PRODUCT CHANGE | CASSETTE 100 MOUNTING BRACKET

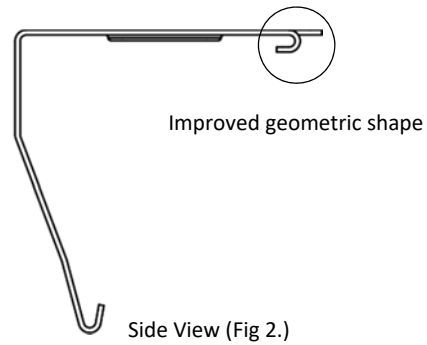
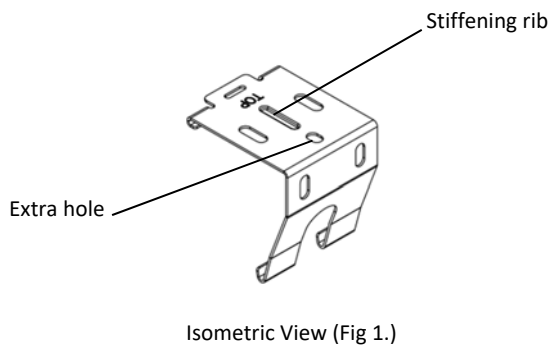
- Improved qualities expand the minimum distance between brackets to 4 feet (122cm).
- The extra screw hole expands the range and accessibility for shallow window installations.

- The stiffening rib makes the bracket stronger (Fig 1.)
- Improved geometric shape at critical points (Fig 2.)
- Increased bracket width for improved support
- Thicker steel makes an improved robust bracket

- Wider look
